BLDG PERMIT NO. 61340

PLANNING CLEARANCE
 (Single Family Residential and Accessory Structures)
Community Development Department

BLDG ADDRESS 2814 Niagara Circle S. TAX SCHEDULE NO. 2943-182-19-001
 SUBDIVISION Niagara Village SQ. FT. OF PROPOSED BLDG(S)/ADDITION Approx. 1200
 FILING II BLK 2 LOT 19 SQ. FT. OF EXISTING BLDG(S) NA
 (1) OWNER A & G Partnership NO. OF DWELLING UNITS
 BEFORE: _____ AFTER: 1 THIS CONSTRUCTION
 (1) ADDRESS 710 S. 15th Street NO. OF BLDGS ON PARCEL
 BEFORE: _____ AFTER: 1 THIS CONSTRUCTION
 (1) TELEPHONE 970-242-8134 USE OF EXISTING BLDGS NA
 (2) APPLICANT Same DESCRIPTION OF WORK AND INTENDED USE: Place new
 (2) ADDRESS Same single family home.
 (2) TELEPHONE Same

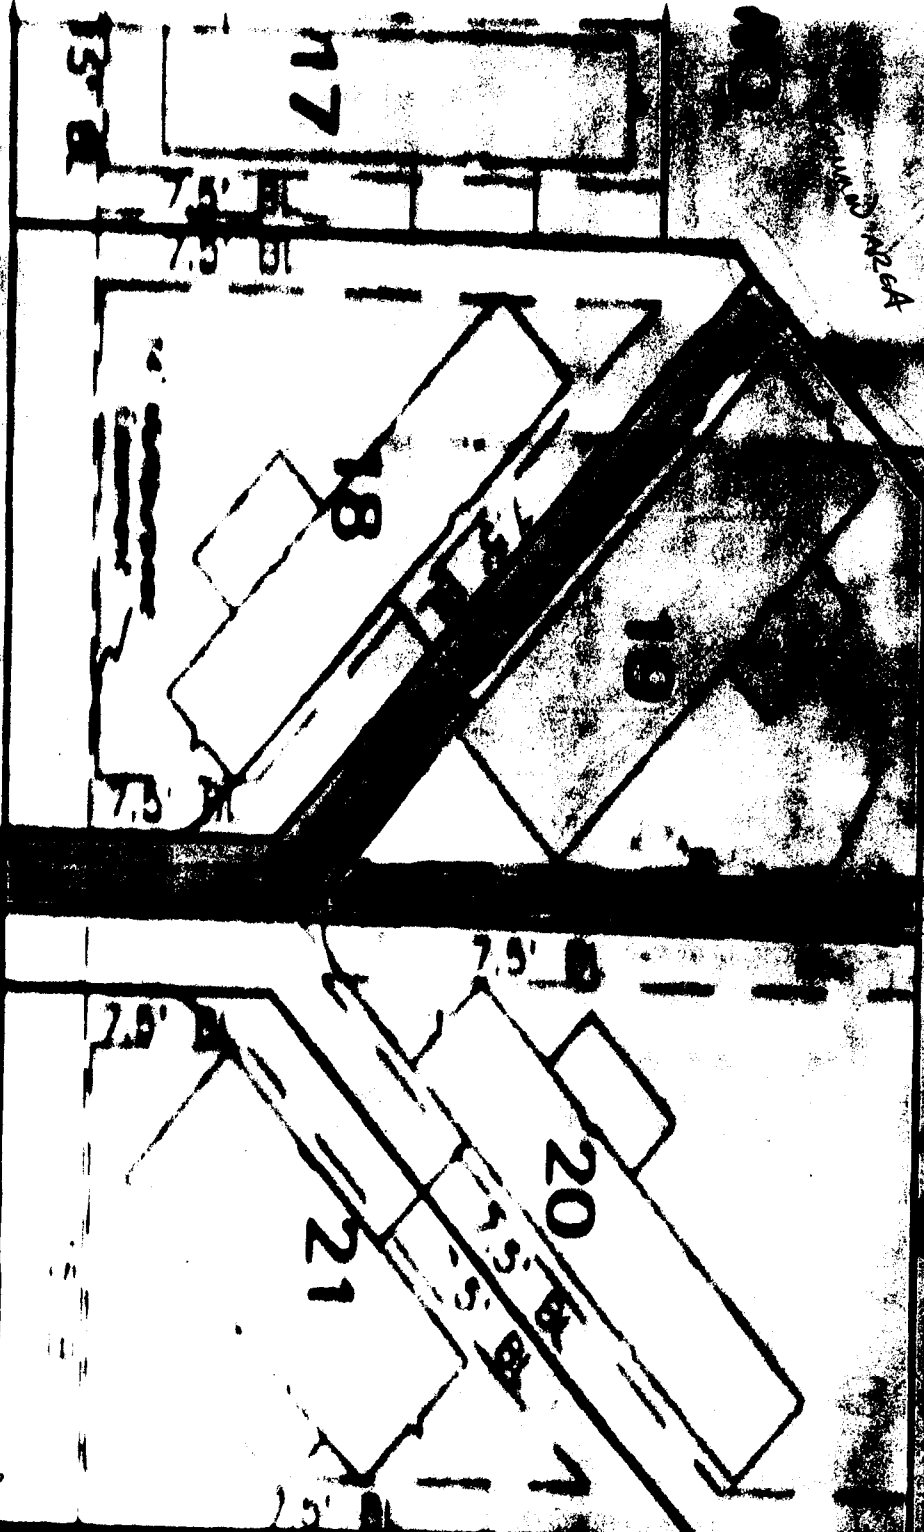
Driveway
LOCATION OK
J. K. Kula
12-20-96

ACCEPTED
ANY CHANGE OF SETBACKS MUST BE
APPROVED BY THE CITY PLANNING
DEPT. IT IS THE APPLICANT'S
RESPONSIBILITY TO PROPERLY
LOCATE AND IDENTIFY EASEMENTS
AND PROPERTY LINES.
